**Section 16 Application under the Town Planning Ordinance (Cap. 131) for
Proposed Underground Vehicular Tunnel Connecting Lee Garden Three (10 Hysan Avenue) and
Lee Garden Eight (8 Caroline Hill Road) below Leighton Road and Sunning Road, Causeway Bay
A/H6/98 – SUBMISSION OF FURTHER INFORMATION 1**

Response to Comments

SECTION 16 PLANNING APPLICATION OF PROPOSED UNDERGROUND VEHICULAR TUNNEL T3 (CONNECTING LEE GARDEN THREE AND LEE GARDEN EIGHT)

Figure 4.5 – Plan Showing Location of the OVT

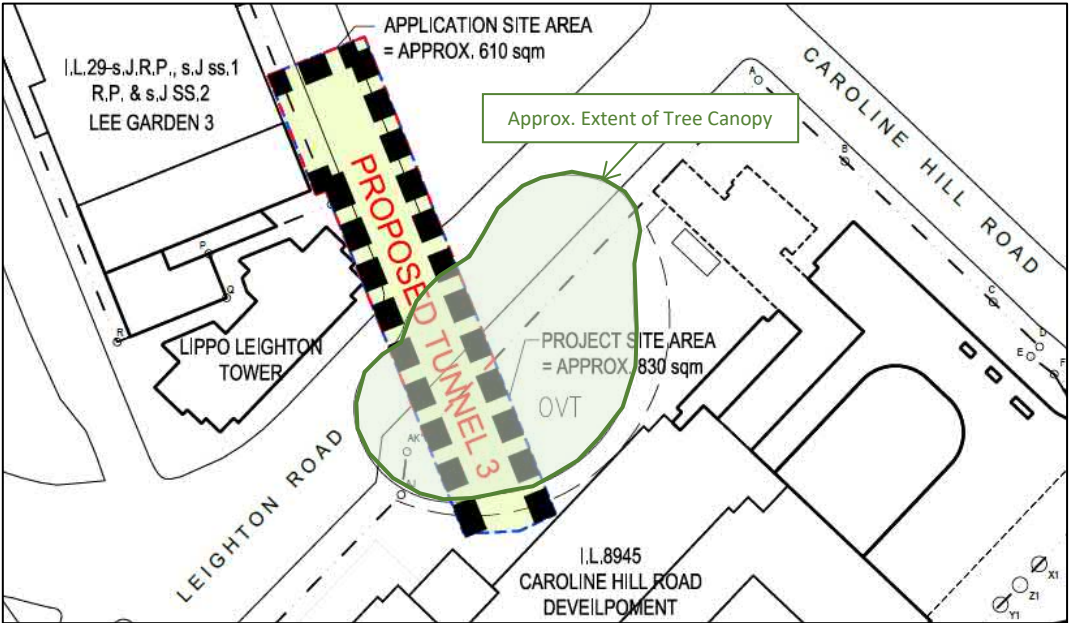
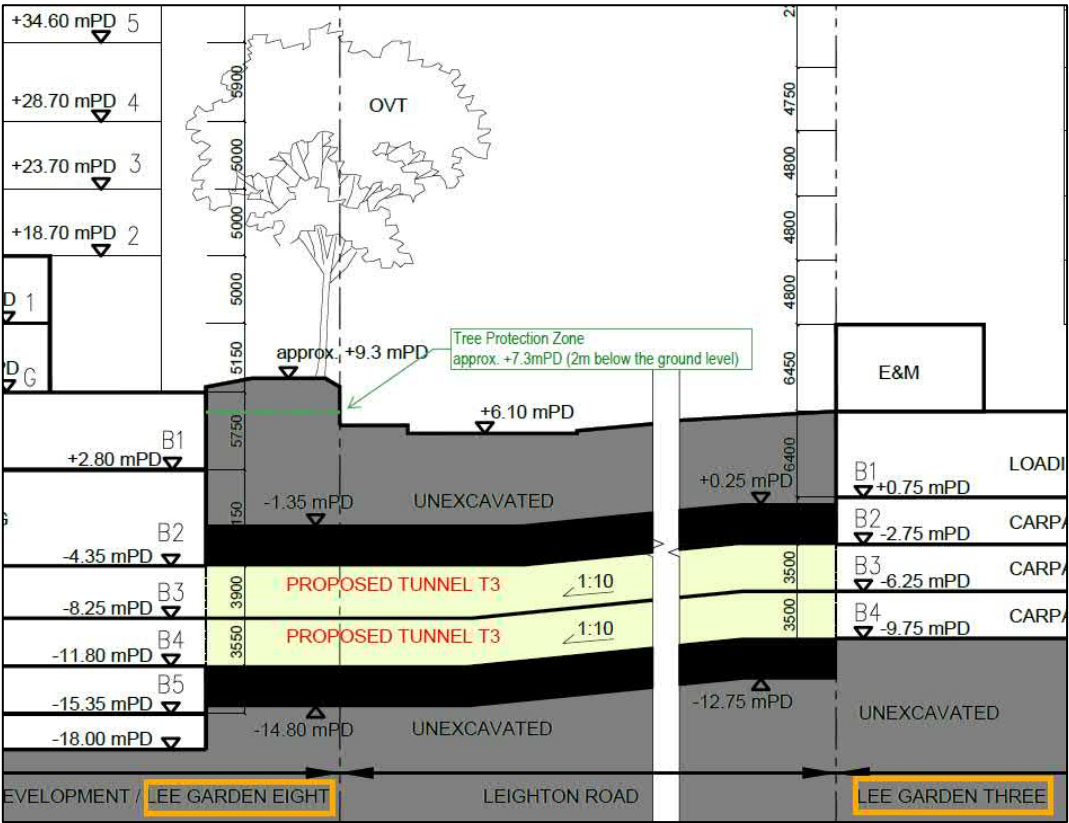
REVISION 0 (submitted on 17 July 2026)		
No.	Comment	Response
	known to be affected by Brown Root Rot Disease and therefore may be more vulnerable to external disturbances. The planning submission has not sufficiently demonstrated that indirect impacts arising from underground excavation, settlement, groundwater regime changes or vibration can be completely avoided. Given the exceptional heritage, landscape and ecological value of the OVT, the precautionary principle should be adopted. In my view, the application should not be approved unless the applicant can provide robust evidence, verified by an independent tree expert, confirming that the tunnel construction and operation would pose no unacceptable risk to the tree's long-term health, survival and structural stability.	entirely underground at a level of approximately –1.35mPD, which is at least 10m below the top of soil of the OVT (approximately +9.30mPD) and approximately 7m below the ground level at Leighton Road (approximately +6.10mPD). In addition, the tunnel is located outside the statutory Tree Protection Zone (TPZ), and no excavation or works at ground level within the dripline are proposed. In addition, the proposed tunnel will pass at least 8m below the 2m deep TPZ (as defined above by DEVB TC 5/2020). Accordingly, direct impacts on the OVT are anticipated to be insignificant. The Applicants recognise the exceptional heritage, landscape and ecological value, as well as the existing Brown Root Rot Disease (BRRD) condition of the concerned OVT. Therefore, notwithstanding the insignificant potential impacts anticipated on the OVT, precautionary tree protection and monitoring measures are proposed. These include strict prohibition of ground-level works within the dripline, control of site access to prevent contamination, implementation of BRRD precautionary measures in accordance with GLTMS guidelines, and regular tree monitoring by qualified arboricultural professionals throughout the construction period. On top of these measures, an Independent Tree Expert will be engaged at a later stage once the detailed construction methodology for the tunnel has been developed. A further method statement, incorporating the advice of the Independent Tree Expert will be provided prior to the commencement of any construction works. Regular tree inspections, photographic records, and tree risk assessments will be undertaken as appropriate to ensure the health, stability, and long-term preservation of the OVT during and after the construction works. Details can be found in Annex B – Tree Protection Proposal. Furthermore, one of the Applicants, who is also the project proponent for Lee Garden Eight, has proposed a series of protection and rehabilitation measures for the OVT under a separate S.16 application (No. A/H7/188), which was approved by Town Planning Board on 24 October 2025. These measures are currently being implemented and will not be undermined by the development of Tunnel T3.

Drawing Title							
NET DIFFERENCES IN TRAFFIC FLOWS DUE TO TUNNELS T3							
Designed	CNM	Checked	CHC	Scale	NTS	Date	APR 2026
Drawing No.						4.11	Rev. A

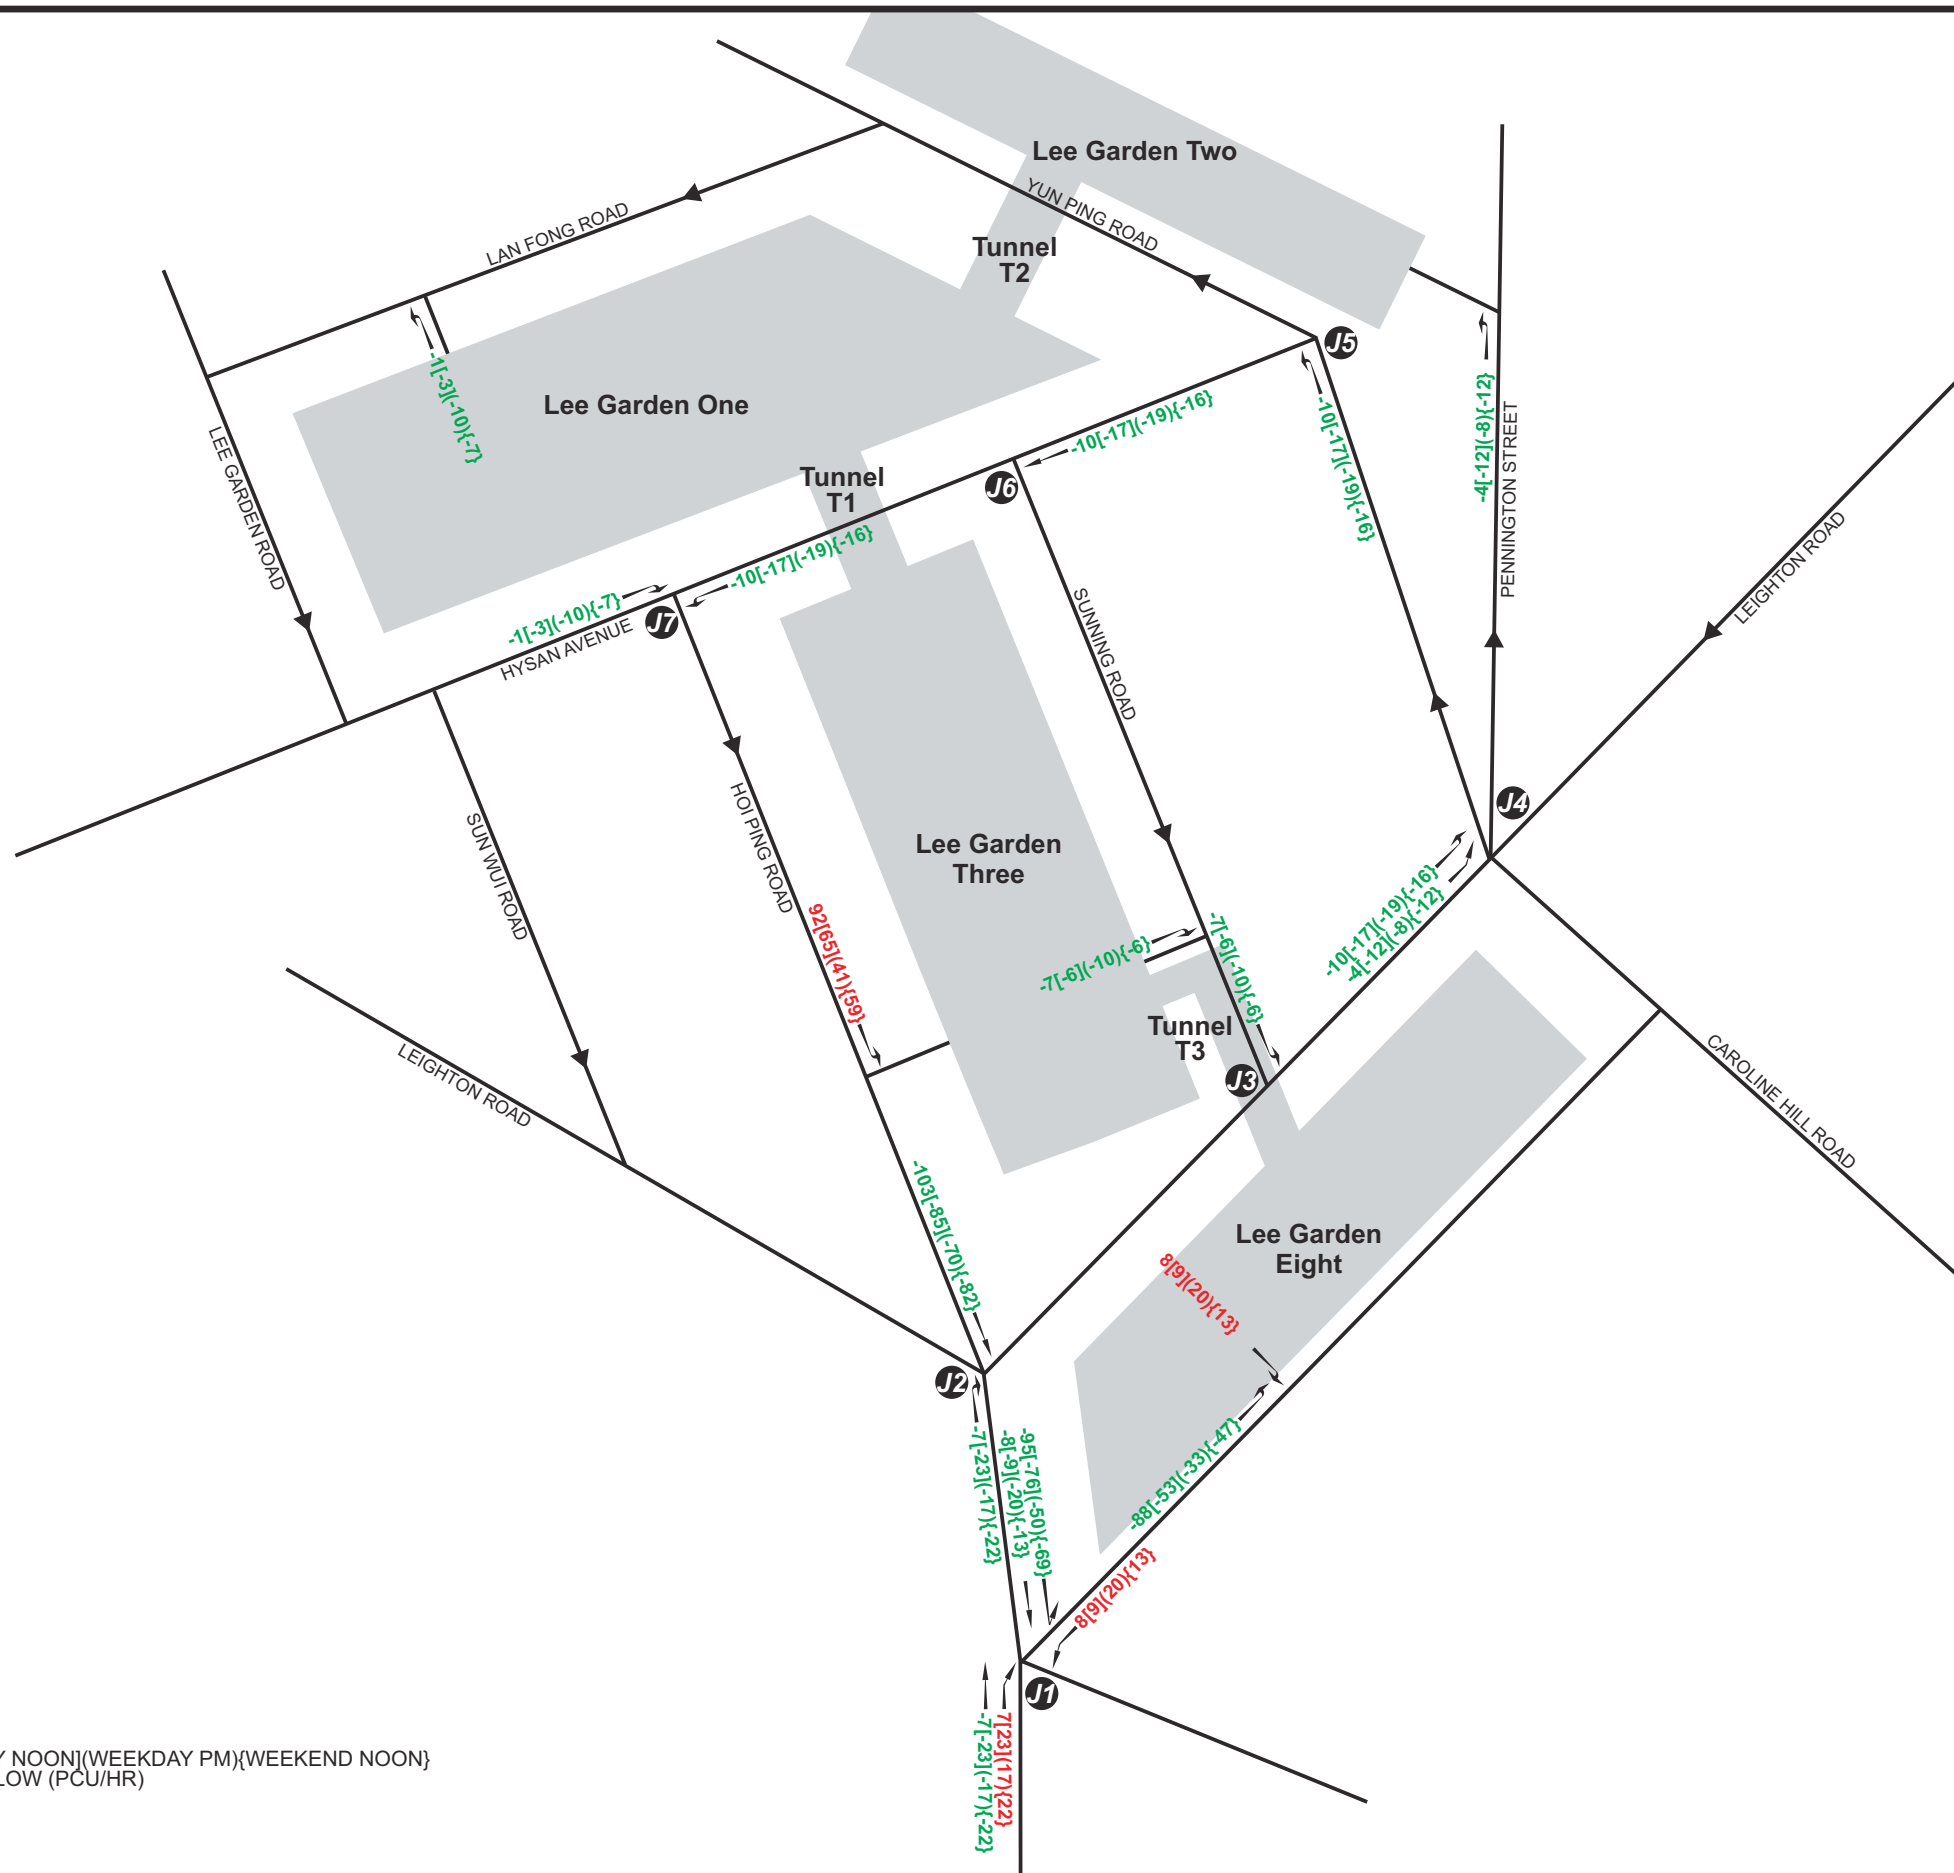
7. Refer to Drawing No. 4.11 – Please advise why the figures showing the net differences in traffic flows due to Tunnel T3 is not just the addition of Drawing Nos. 3.1 and 3.7. Please review.	It is clarified that the net differences in traffic flows presented in Drawing No. 4.11 are rounded to the nearest 5 and derived with reference to (i) the directional splits of the ingress and egress traffic of Lee Garden One, Lee Garden Three and Lee Garden Eight as presented in Drawing Nos. 3.7, 3.9 and 4.2 respectively; and (ii) the following anticipated diversions from the reference scenario (with Tunnels T1 & T2) to the design scenario (with Tunnels T1, T2 & T3): • Ingress of Lee Garden One from the south via Lee Garden Eight instead of Lee Garden Two

REVISION 0 (submitted on 17 July 2026)		
No.	Comment	Response
		- Egress of Lee Garden One to the south via Lee Garden Eight instead of Lee Garden One - Ingress of Lee Garden Three from the south via Lee Garden Eight instead of Lee Garden Three - Egress of Lee Garden Three to the south via Lee Garden Eight instead of Lee Garden Three - Ingress of Lee Garden Eight from the west via Lee Garden Three instead of Lee Garden Eight For easy reference, Drawing No. 4.11 has been revised, presenting the exact traffic flows instead of rounded figures.

Drawing Title			
INDICATIVE WORKS AREA FOR TUNNEL CONSTRUCTION AT LEE GARDEN EIGHT AND LEE GARDEN THREE			
Designed	MHC	Checked	TCW
Scale	As Shown(A3)	Date	JUL 2026
Drawing No.	7.1	Rev.	A

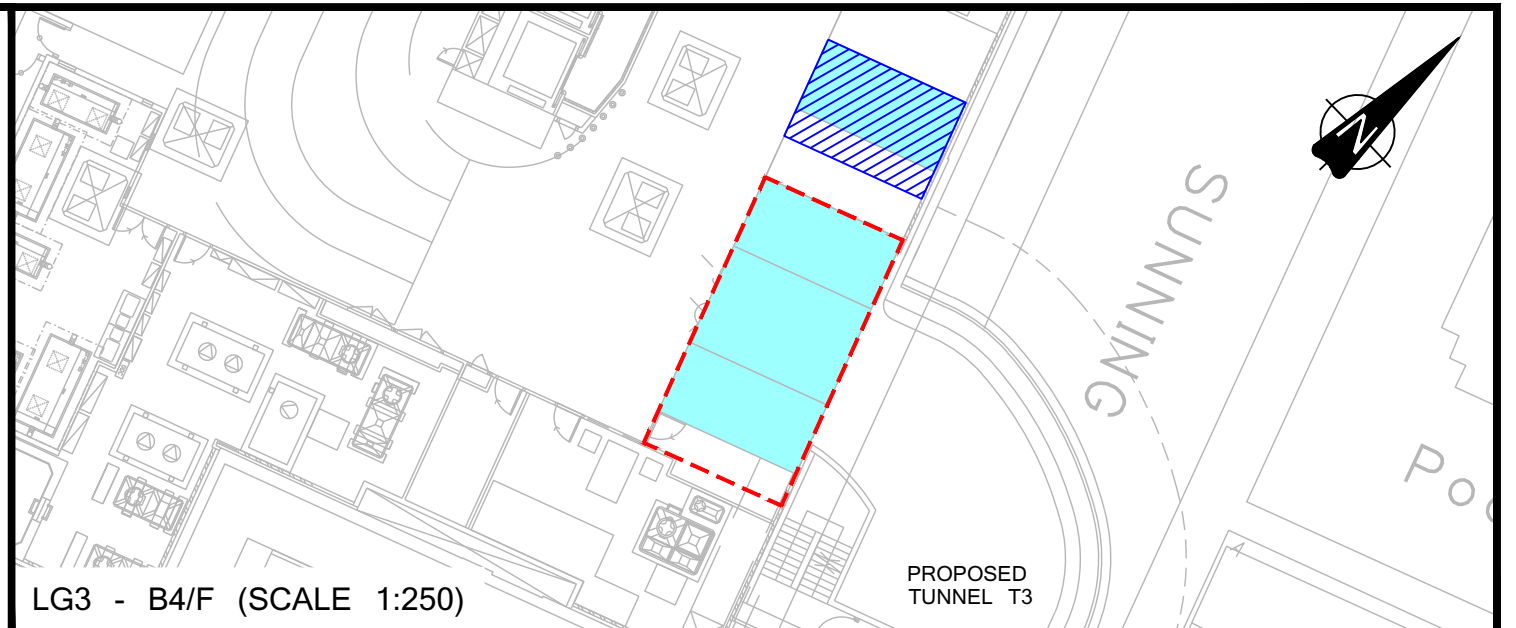
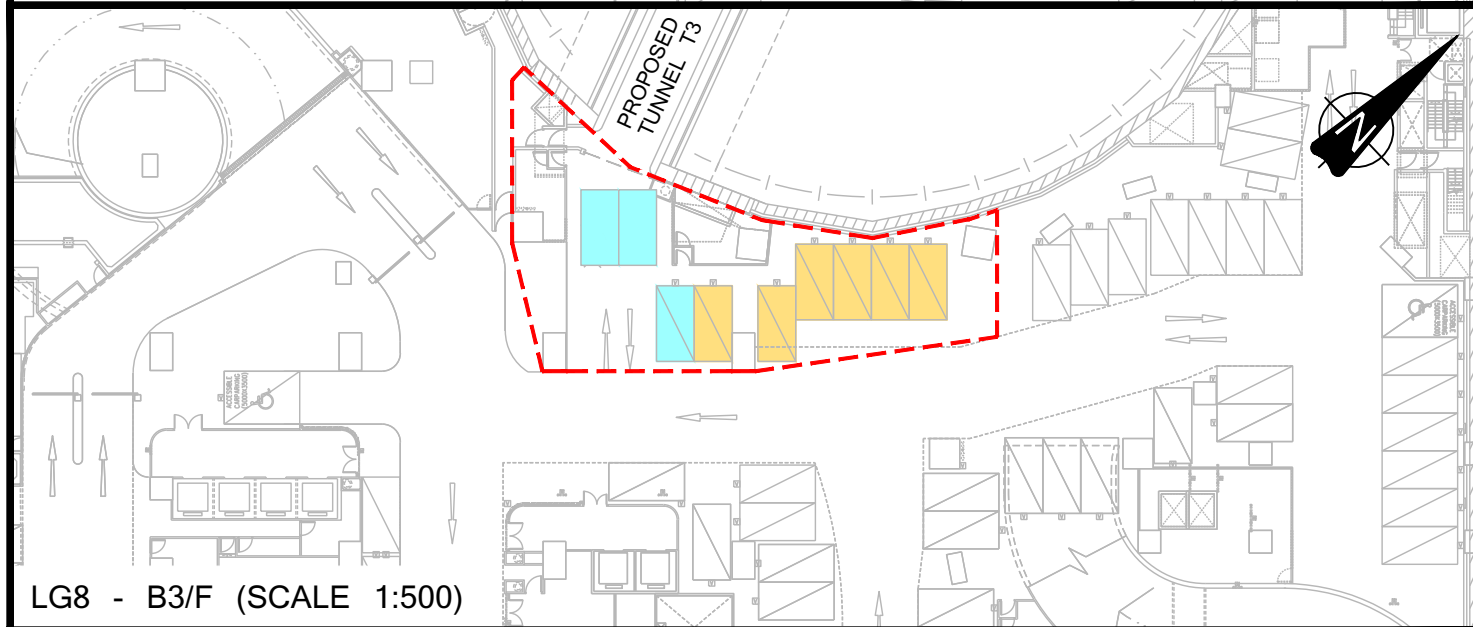
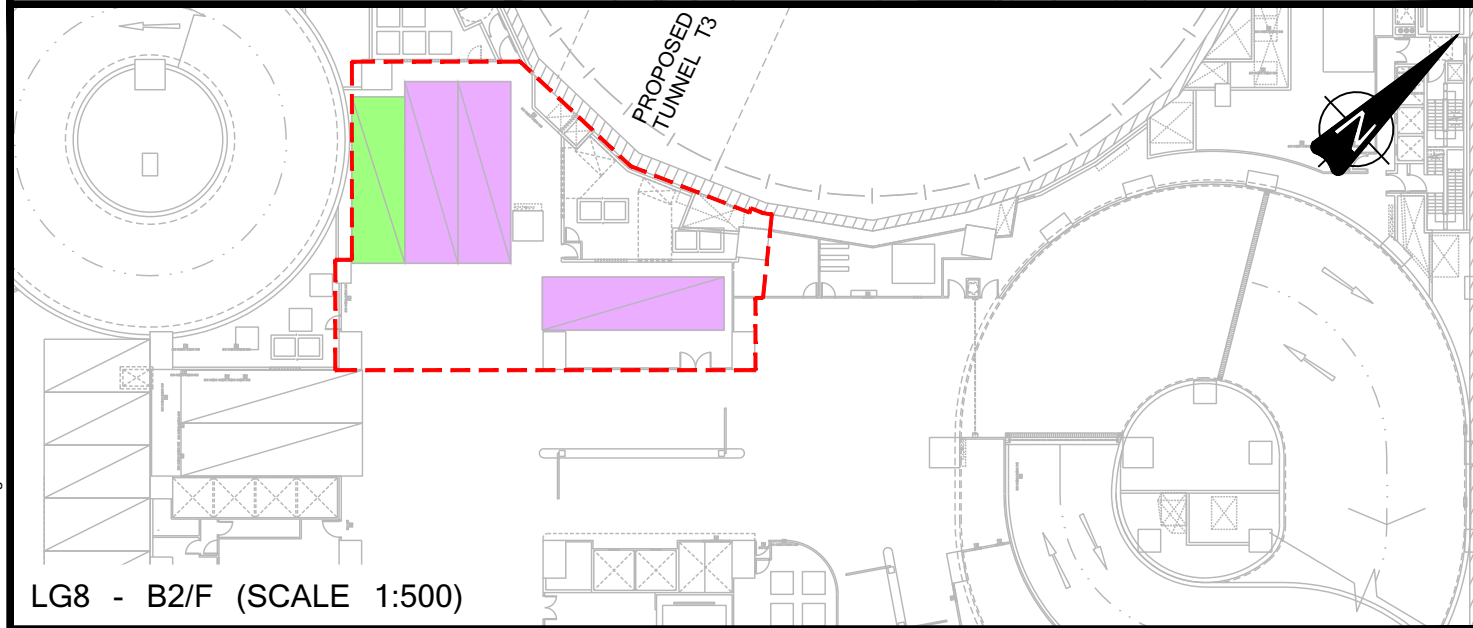
8. Refer to Section 7.2.2 and Drawing No.7.1, it is advised that 5 nos. MGV/HGV parking spaces and 5 nos. of coach parking spaces would be suspended. Please advise why the MGV/ HGV / coaches parking spaces on B2/F level need to be suspended with the tunnel construction on B3/F and B4/F levels. Please consider to suspending PCs parking spaces on B3/F and B4/F instead of suspending the MGV/ HGV/ coaches parking spaces on B2/F, as MGV/ HGV/ coaches parking spaces are the PVP requirements in the OZP.	Since the headroom on B3/F is designated for private cars only, construction vehicles would not be able to access the works area on B3/F and B4/F. Therefore, working space and a floor opening on B2/F would be required for internal lifting and delivering major plant, equipment (e.g. the tunnelling machine) and materials from B2/F to the works area on B3/F. As per the preliminary review, it would potentially affect 3 nos. coach parking spaces and 1 no. HGV parking space on B2/F, as presented in Drawing No. 7.1. As mentioned in Section 7.2.2, if the MGV/HGV/coaches PVP on B2/F will be affected during construction stage, the ancillary loading bays would be temporarily converted into the spaces for re-provisioning of the affected public parking spaces to maintain the 24-hr provisions for the public needs. The details of temporary relocation will be reviewed in the detailed design stage and submitted for TD's review and approval prior to the construction works.

9. Besides, if the MGV/HGV/ coaches parking spaces are required to be suspended, please show the exact locations of the suspended MGV/ HGV/ coaches parking spaces during construction stage.	The potentially affected 3 nos. coach parking spaces and 1 no. HGV parking space at B2/F are indicated in Drawing No. 7.1.
